TECHNICAL EVALUATION REPORT

RADIOLOGICAL EFFLUENT TECHNICAL SPECIFICATION IMPLEMENTATION (A-2)

INDIAN POINT NUCLEAR POWER PLANT UNIT 2

NRC DOCKET NO. 50-247

Figure 1. Liquid Radwaste Treatment Systems, Effluent Paths, and Controls for Indian Point Nuclear Power Plant Unit 2

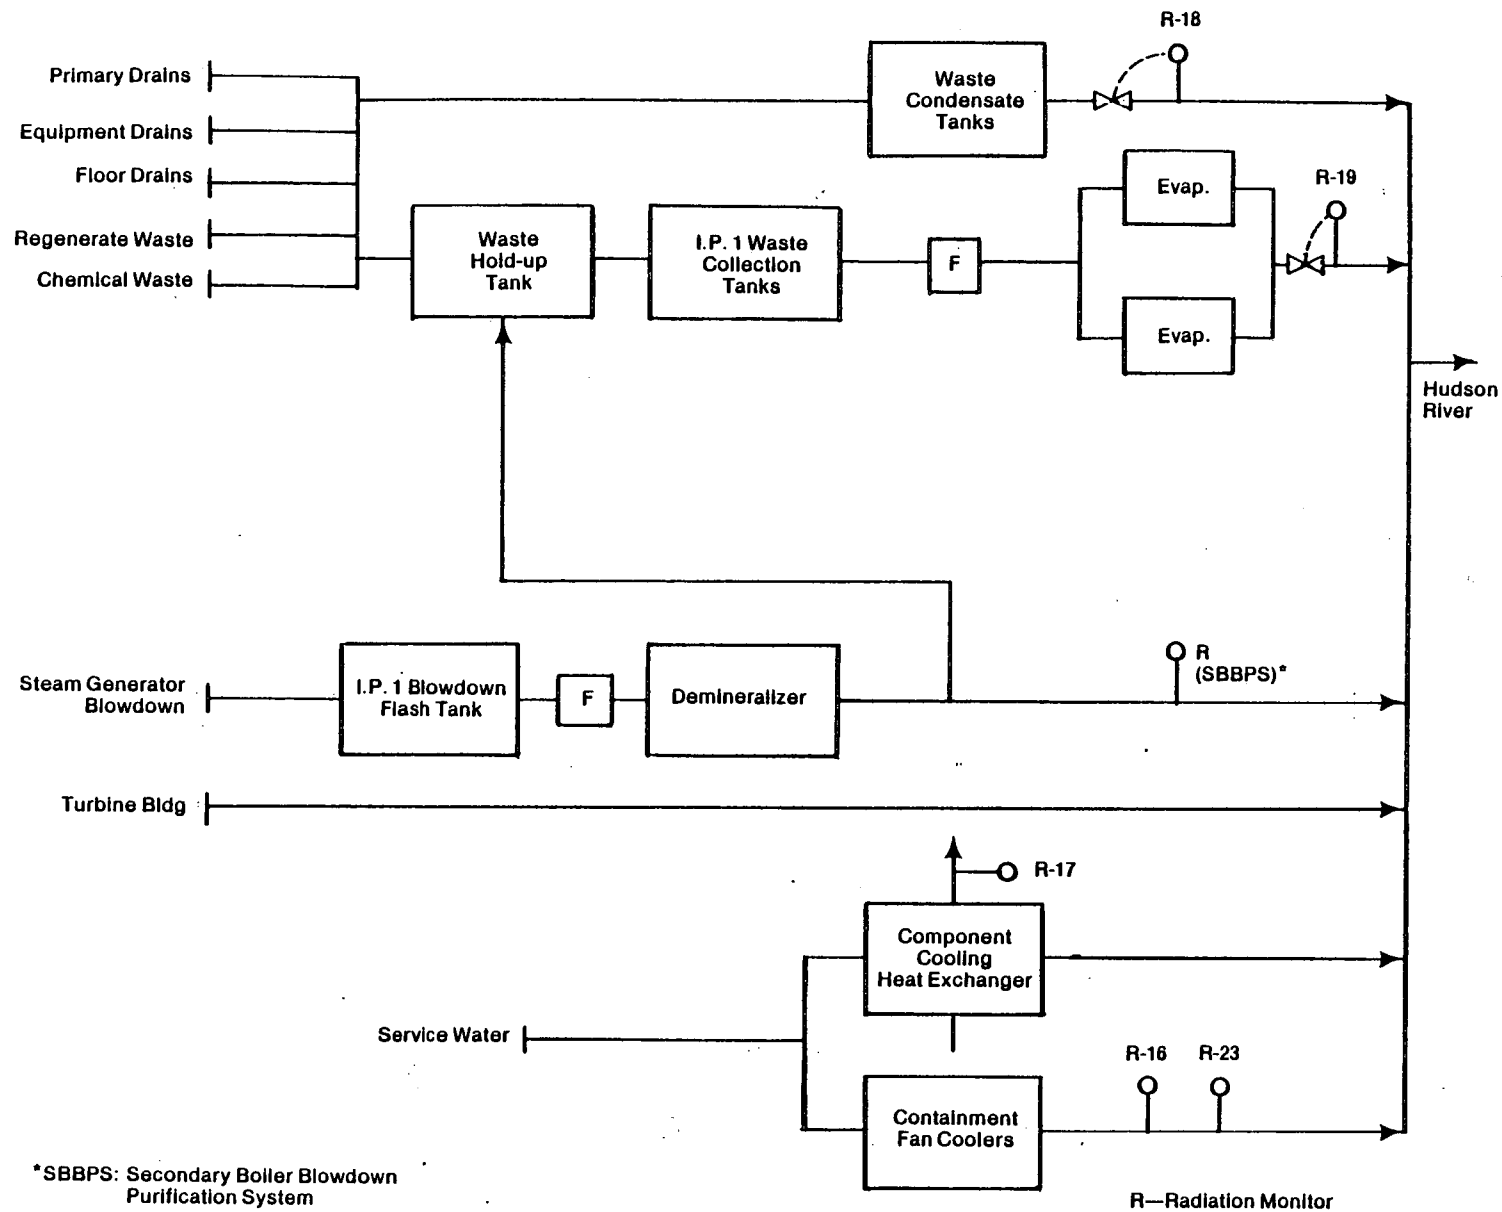
A diagram of the liquid effluent release paths indicating the location of the liquid effluent monitors is shown in Figure 1. The radioactive liquid wastes originating from the primary drains, equipment drains, floor drains, regenerate waste, and chemical waste are collected in the waste condensate tank and waste holdup tank. Liquid waste from the waste condensate tank is monitored and controlled by the waste disposal liquid effluent monitor (R-18). Liquid waste from the waste holdup tank is processed through evaporators and is monitored and controlled by the steam generator blowdown effluent monitor (R-19) prior to release to the environment. Liquid waste from the steam generator blowdown can also be collected in the waste holdup tank after filtration and demineralization if further processing is required. Liquid waste from the steam generator blowdown that does not require further processing is monitored by the Unit 1 secondary boiler blowdown purification system (SBBPS) effluent monitor. The turbine building floor drains are imbedded in the concrete foundation and, hence, inaccessible and unmonitored.

Figure 2. Gaseous Radwaste Treatment Systems, Effluents Paths, and Controls for Indian Point Nuclear Power Plant Unit 2

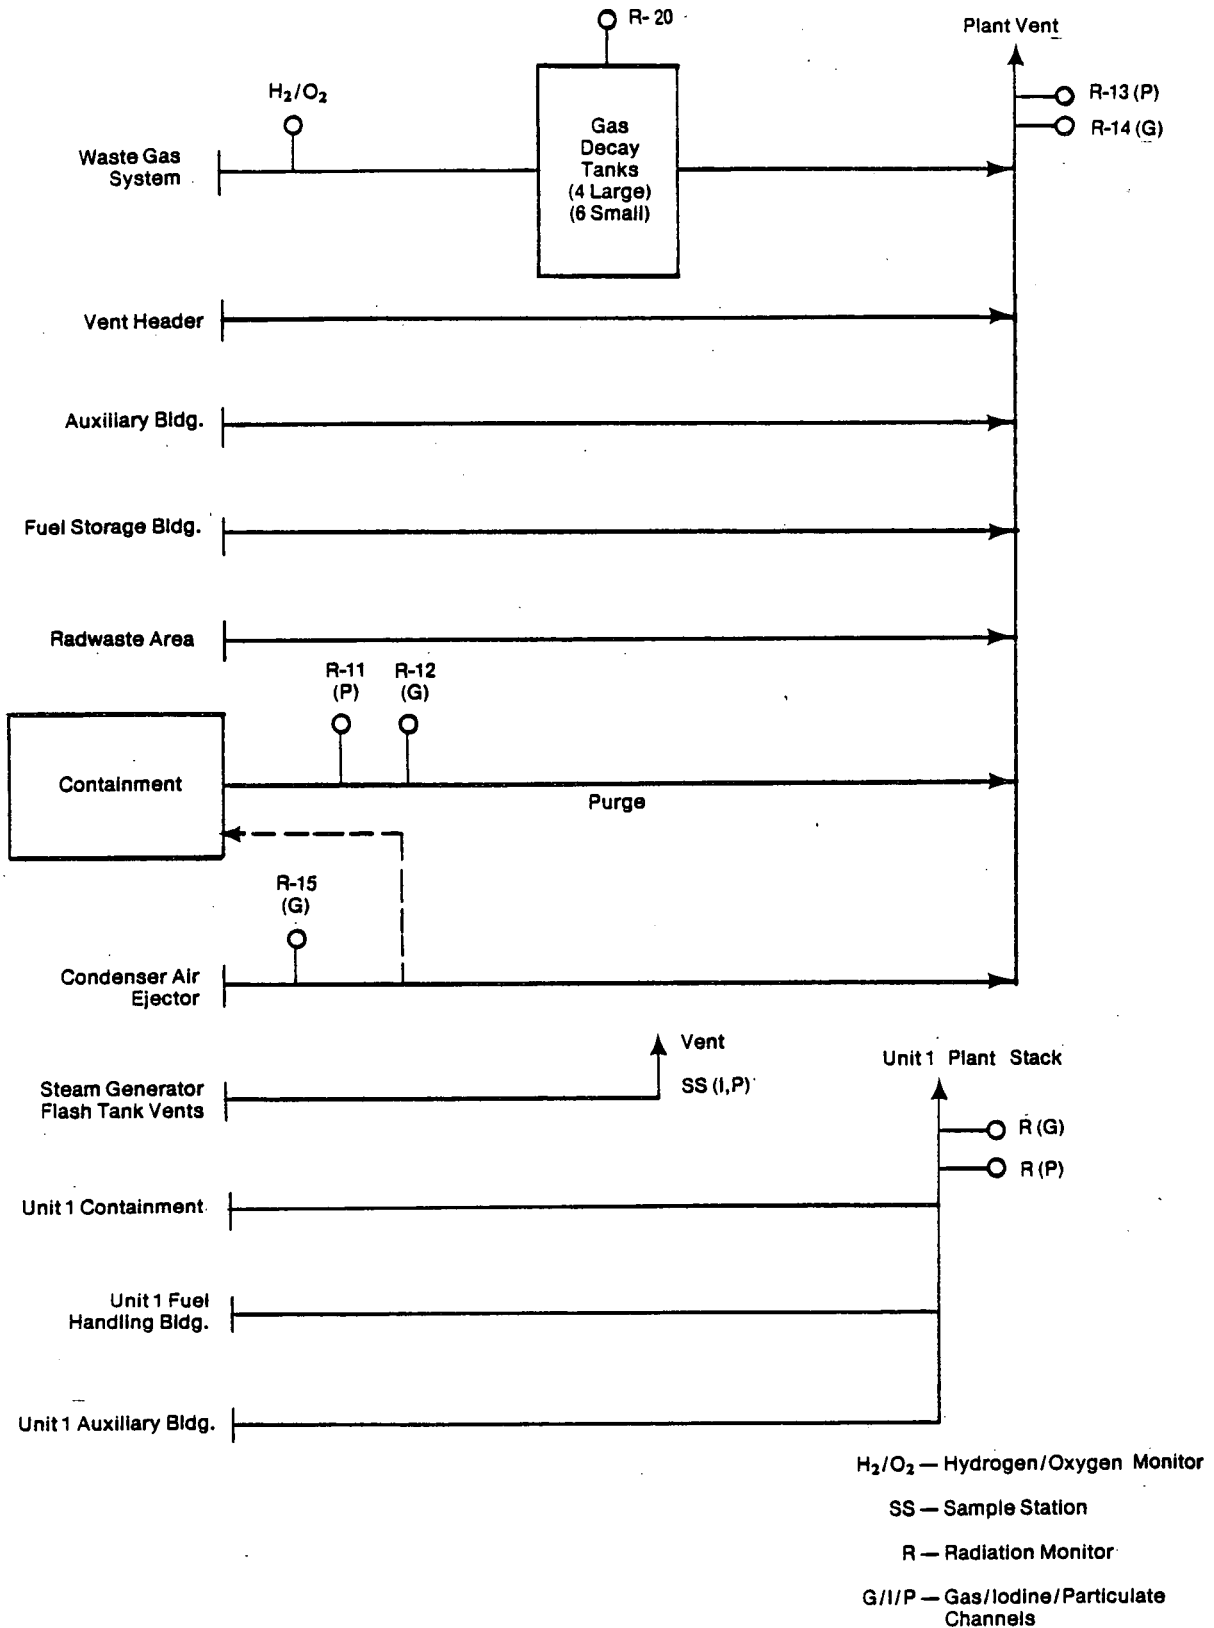
A diagram of the radioactive gaseous effluents indicating the location of effluent radiation monitors and process treatment equipment is shown in Figure 2. Indian Point Unit 2 has a plant vent which is a combined release point for the major sources of gaseous effluents from the plant. Other gaseous effluent releases from the site addressed by the radiological effluent technical specifications for Indian Point Unit 2 are releases from the Unit 1 plant stack and the steam generator flash tank vents. Releases from the plant vent and the Unit 1 plant stack are monitored; releases from the steam generator flash tank vents are unmonitored.
